ANADROMOUS FISH EVALUATION PROGRAM
Fish Facility Design Review Work Group
Minutes
February 25 and 26, 2004

The Fish Facility Design Review Work Group (FFDRWG) meeting was held in the Harvest Room on February 25 and 26, 2004, at the U.S. Army Corps of Engineers (Corps), Walla Walla District (District), 201 North Third Avenue, Walla Walla, Washington. Marvin Shutters organized the meeting, and Tonia Elsey served as note taker. The meeting was audio taped in order to facilitate completion of the minutes.

Figure 1 – Isometric of Alternative 1

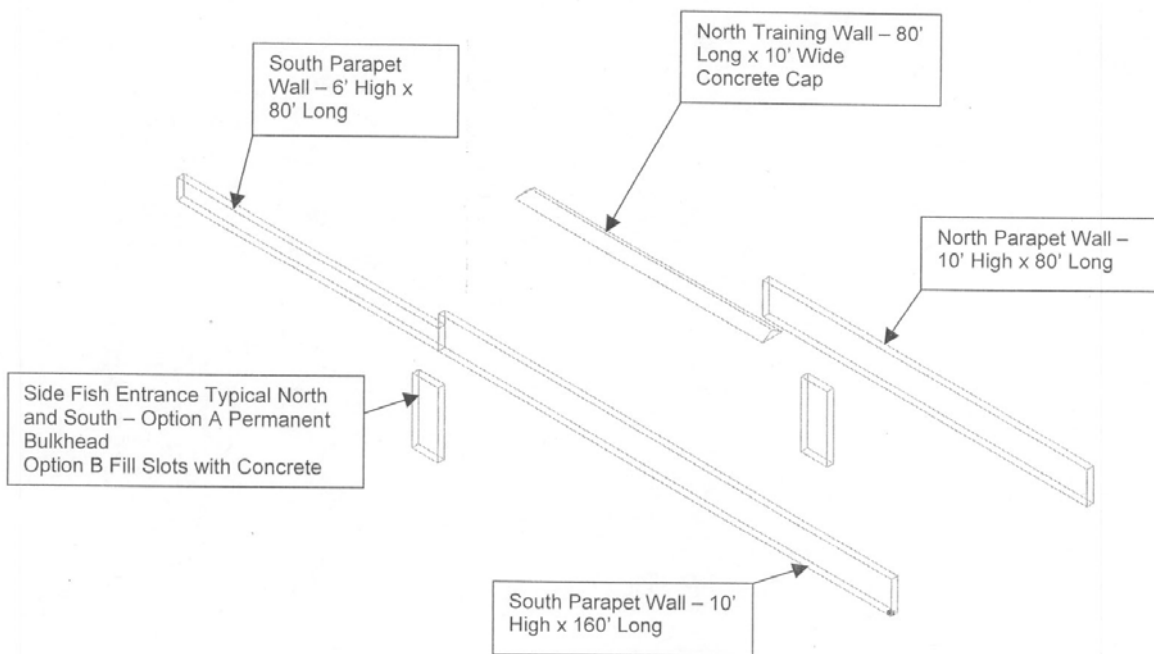
a. Alternative One: On the south side, the dimensions for the wall would be 10 feet high by 160 feet long. That would step down to a 6-foot by 80-foot wall. The north shore wall would be a 10-foot by 80-foot wall. The north shore has an existing training wall that is 10 feet wide. There was some concern about the possibility of fish

becoming stranded on the training wall. The team is looking at placing a slanted cap on the wall so that any fish that got out there would fall off into the water. The estimated cost for this alternative would be \$215,000. There are currently side fish entrances on both the north and south shores with gates that are never used and would not need any structural work conducted on them. Operationally, there might be some advantage to installing permanent bulkheads (\$228,540) or filling the void with concrete (\$362,080) to obtain a flush wall against that mouth. Filling the void with concrete would require some in-water work. There was discussion on the installation of bulkheads versus filling the void with concrete.

There was discussion on the three alternatives. After much discussion, FFDRWG opted for Alternative One with a possible alternative to filling the void without having to cast concrete in place underwater.

Appendix, Handout 4, Alternates
Alternate 1

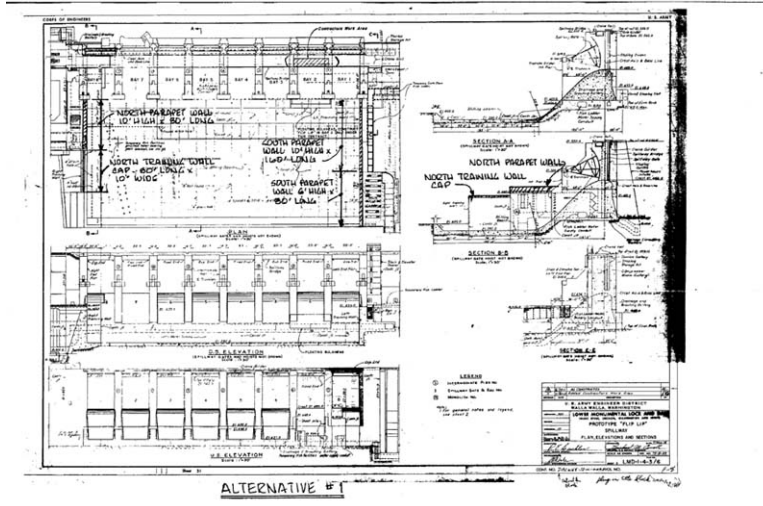
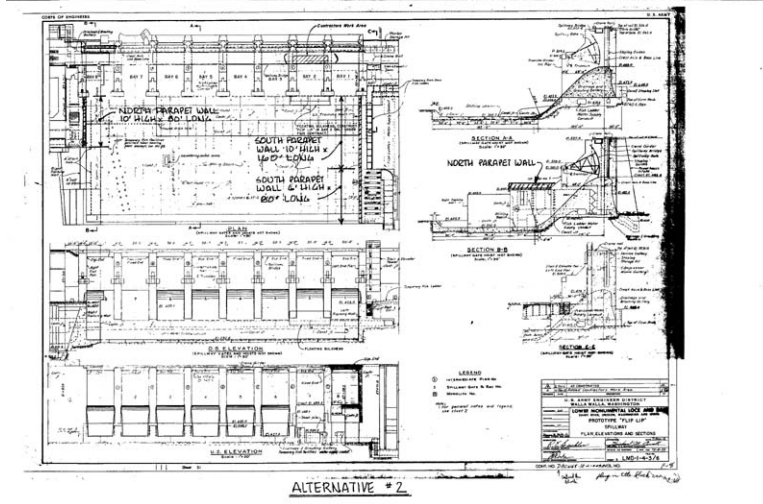
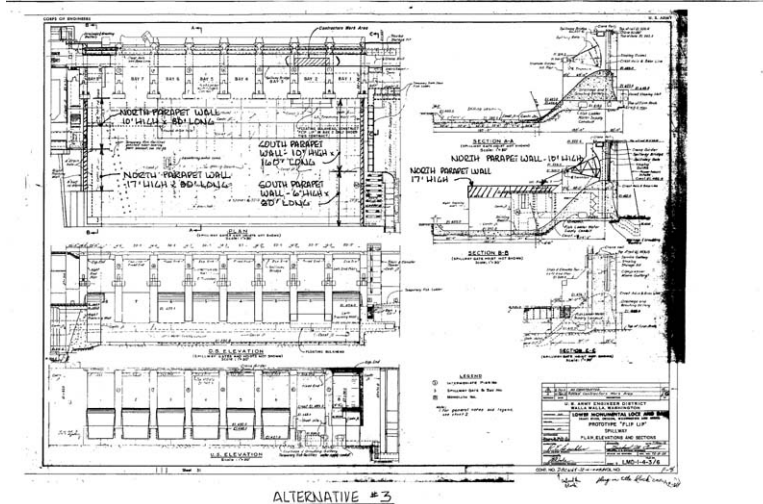
b. Alternative Two: This alternative is basically all the same components as Alternative One minus the cap on the training wall. The estimated cost would be \$162,000; \$275,700 with the permanent bulkheads or \$309,240 to fill the void with concrete.

c. Alternative Three: There is a lot of material involved with the cap for the training wall, so this alternative considers constructing the parapet wall all the way out to the end of the training wall on the north shore. The estimated cost for this alternative is \$237,620; \$351,000 with the permanent bulkheads or \$384,700 for the concrete fill.

Appendix, Handout 5c

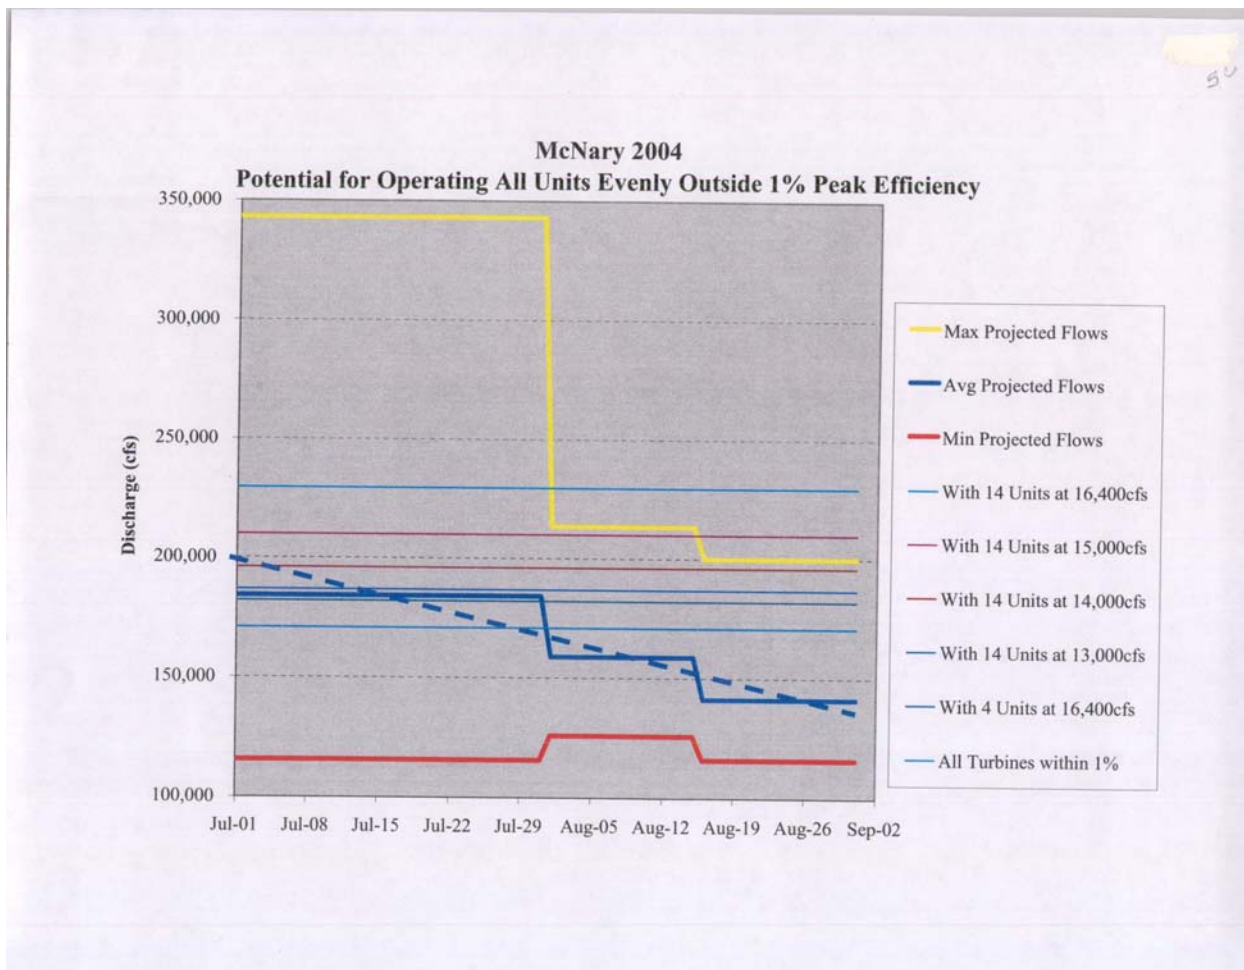
Kim Fodrea explained the graphs that depict summer operation conditions (see appendix, handouts 5b and 5c). Kim stated the bold yellow, blue, and red lines are the latest forecasts from heights and modeling (typical 14-period type model). The blue line represents the average anticipated forecast. The red and yellow lines represent the range that is being forecasted as the possibility around the blue line forecast. The smaller colored lines represent the powerhouse capacity for different operations. The bottom line (all turbines within 1 percent) represents 12.2 kcfs). Then the line steps up

to adding 4 units at 16.4 kcfs (covers the McNary Modernization testing) and incrementally continuing to add more units at the maximum turbine discharge. She stated, if on July 1, there is 200 kcfs (indicated by the broken line), BPA would propose to operate the powerhouse with 6 to 8 units at 16,400 cfs. Rebecca Kalamasz asked why BPA would propose to operate outside the 1 percent if they could operate more units within 1 percent. Kim explained all the units would already be up to the 1-percent limit (170 kcfs), and at 200 kcfs, there would be more water available. The first proposal would be to operate 6 to 8 units outside the 1 percent with the rest of the units operating within the 1 percent (12.2 kcfs). The second proposal would be to operate with all 14 units at 14 kcfs, which would put all the units outside the 1 percent, but not at the fearful 16.4 kcfs. Kim stated there is a power revenue advantage to going outside the 1 percent late in the season. There was discussion on the graphs and proposed operations.

Appendix, Handout 5d

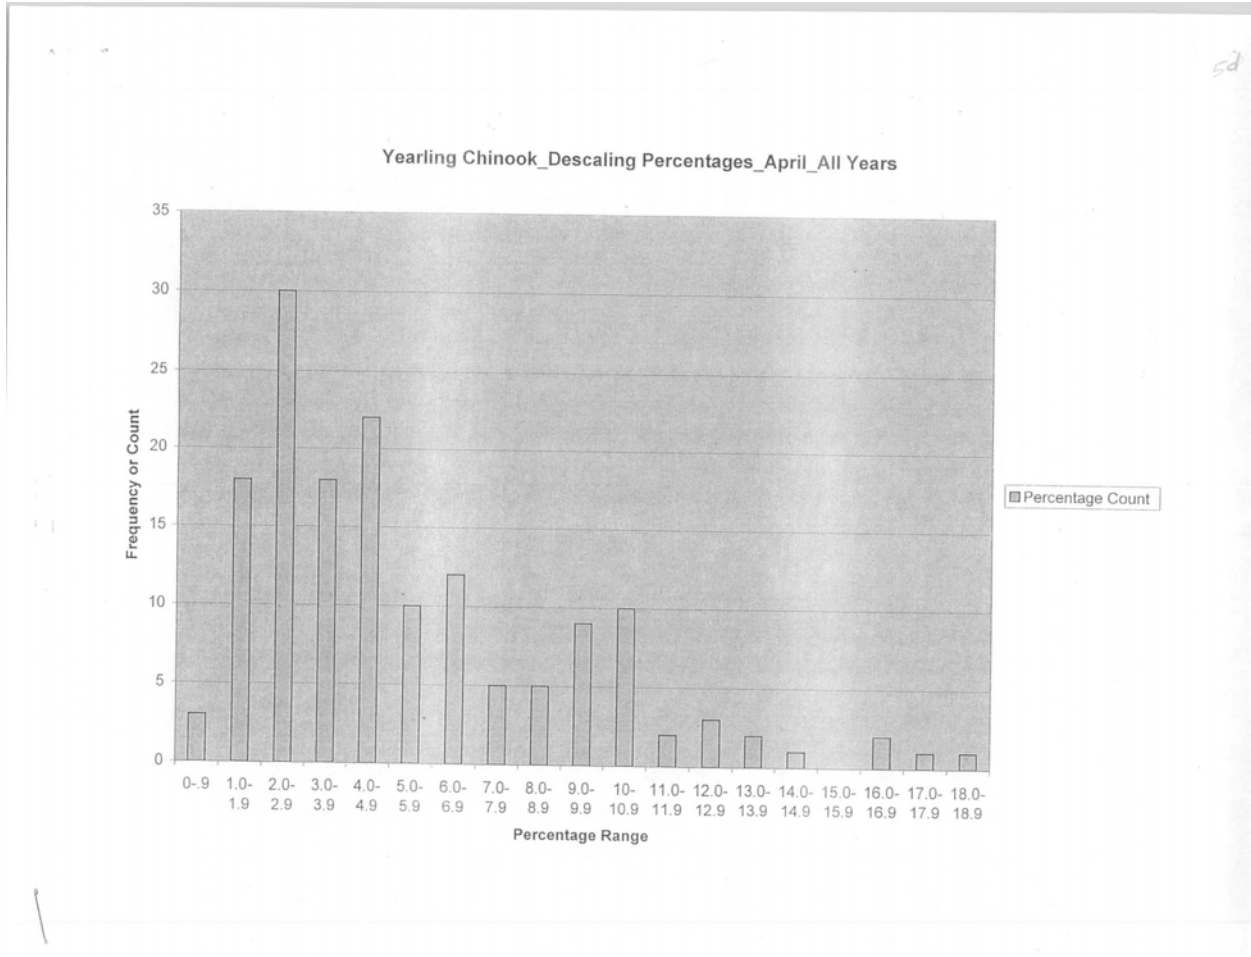
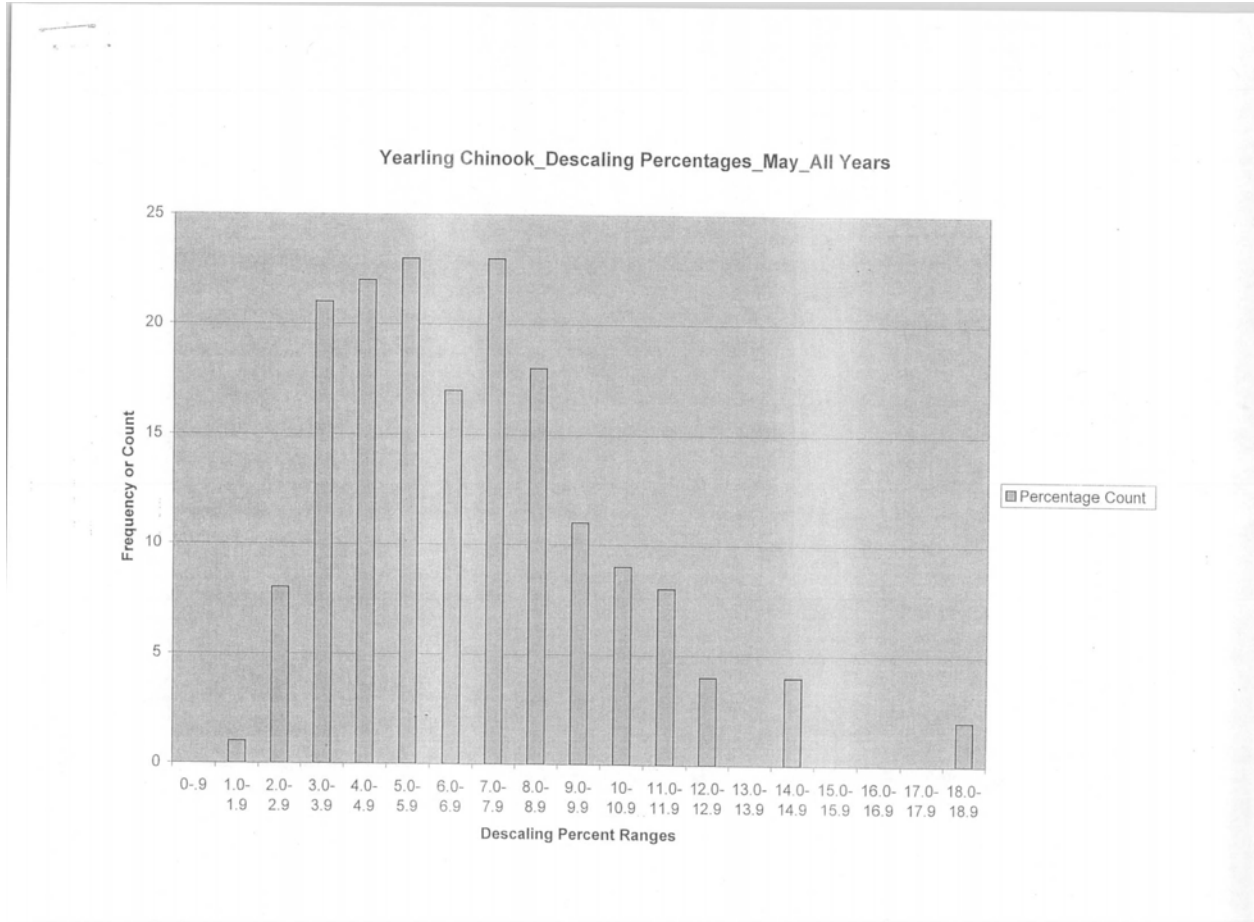
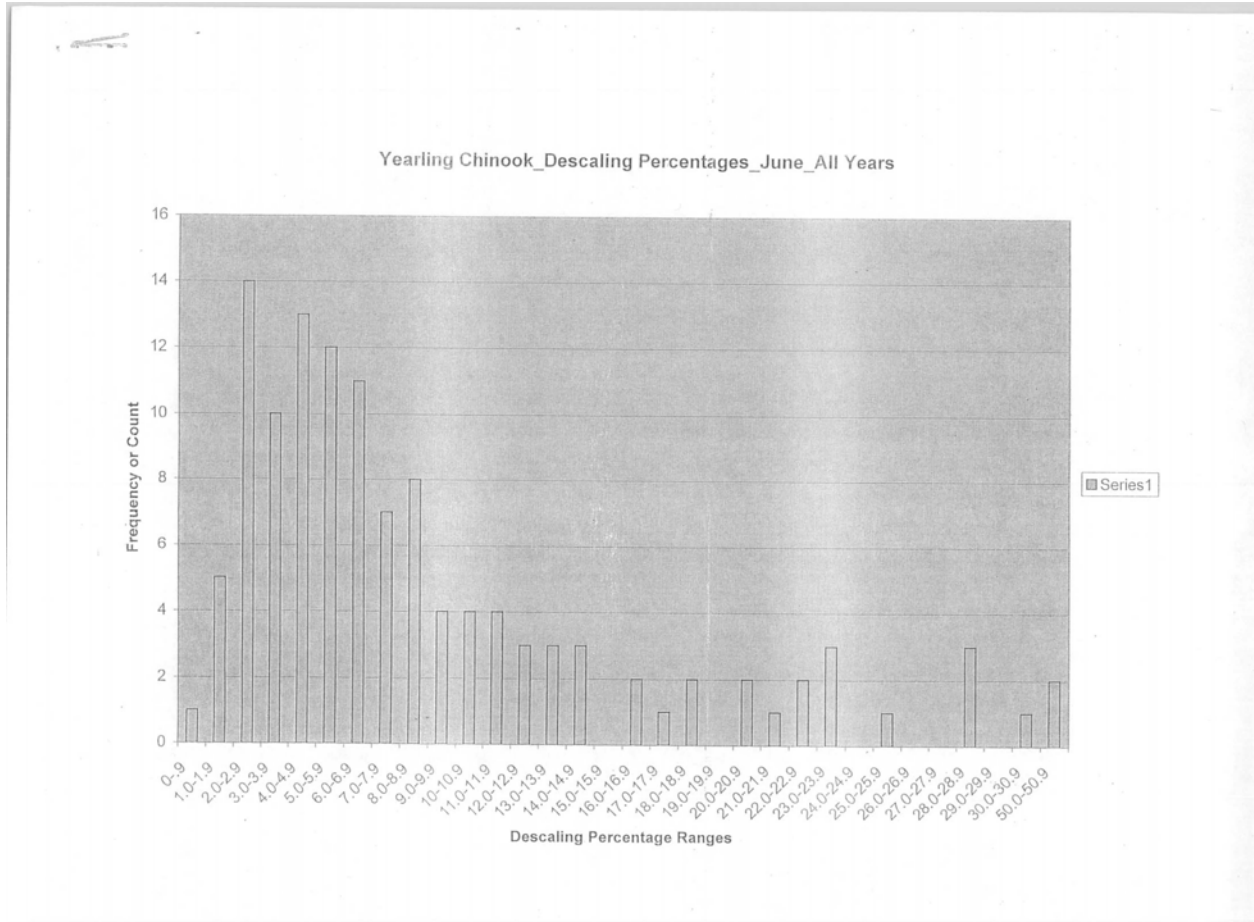
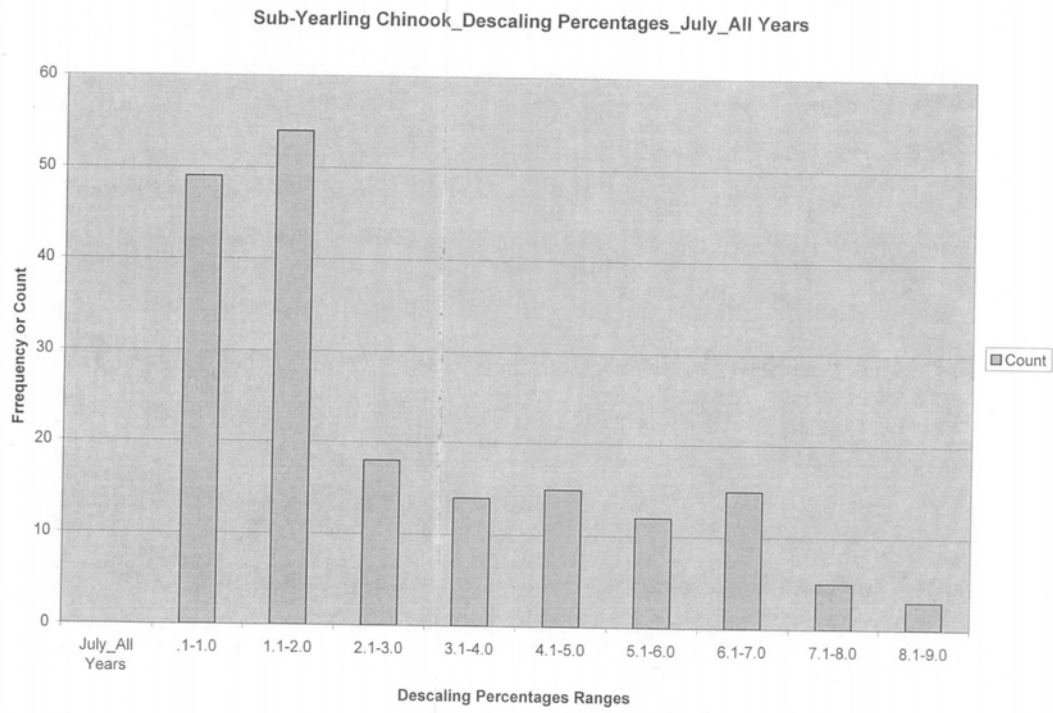
Marvin Shuttles explained the graphs depicting yearling and subyearling chinook descaling percentages (see appendix, handouts 5d and 5e). Marvin stated the handouts depict the daily frequency percentage of descaling using sample fish from McNary (over a 4-year period). The group discussed the graphs and how the data could be used to develop plans for detecting increased descaling percentages. Marvin explained the graph depicts that, over a 4-year period, there were 10 days where descaling was over 4 percent. Mike Gessell stated the graphs are proof that the vast majority of descaling for yearling chinook occurs in June. There was discussion on the graphs and descaling problems at McNary. Rebecca Kalamasz stated one task is to determine at what level of descaling does project personnel assess the project, PIT-tag data, and the condition of fish arriving from other projects to make the decision to change operations back to within 1 percent. The second task is to determine at what level is the emergency stop criteria threshold, how high above the baseline data before turbine operation is automatically lowered to within 1 percent. There was discussion on the descaling problems at McNary and how best to address it.
